FORMER THALES SITE

PRELIMINARY PLAT

1ST SUBMITTAL DECEMBER 23, 2020 2ND SUBMITTAL APRIL 1, 2021

Engineering_11-02-2021

- MOUNTABLE CURB

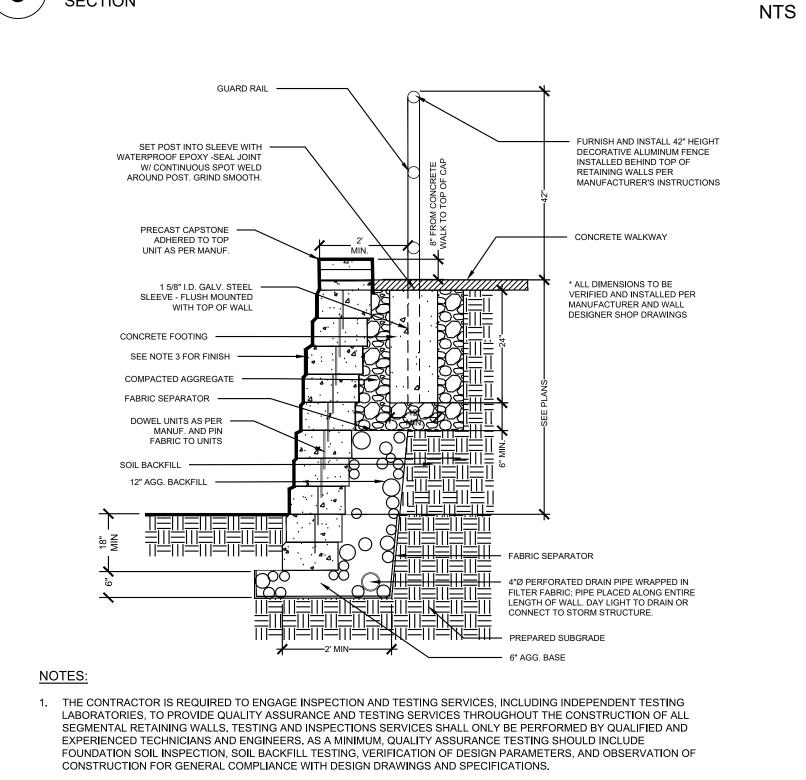
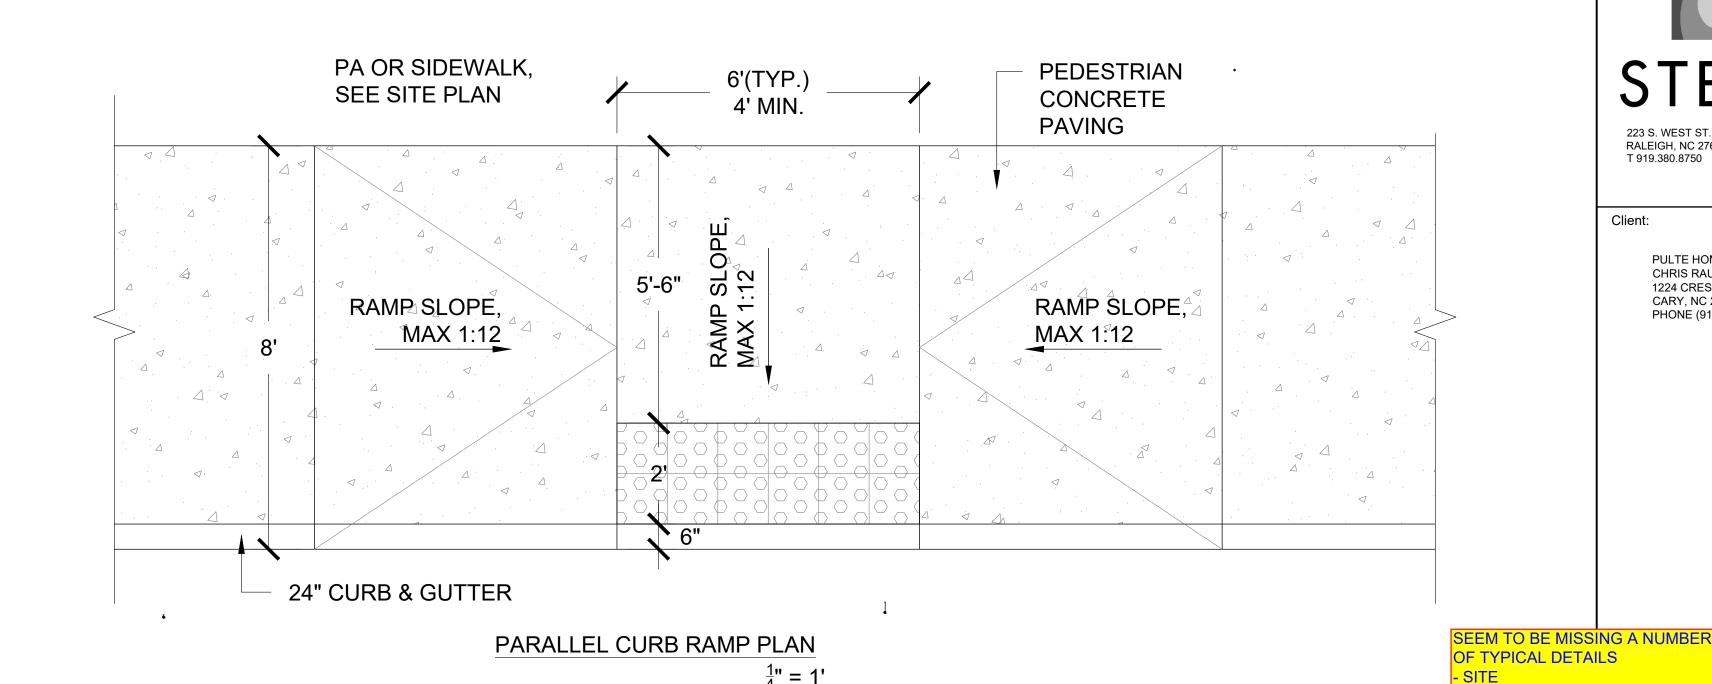
CAN WE HAVE A 30" MOUNTABLE CURB TO BE USED THROUGHOUT DEVELOPMENT
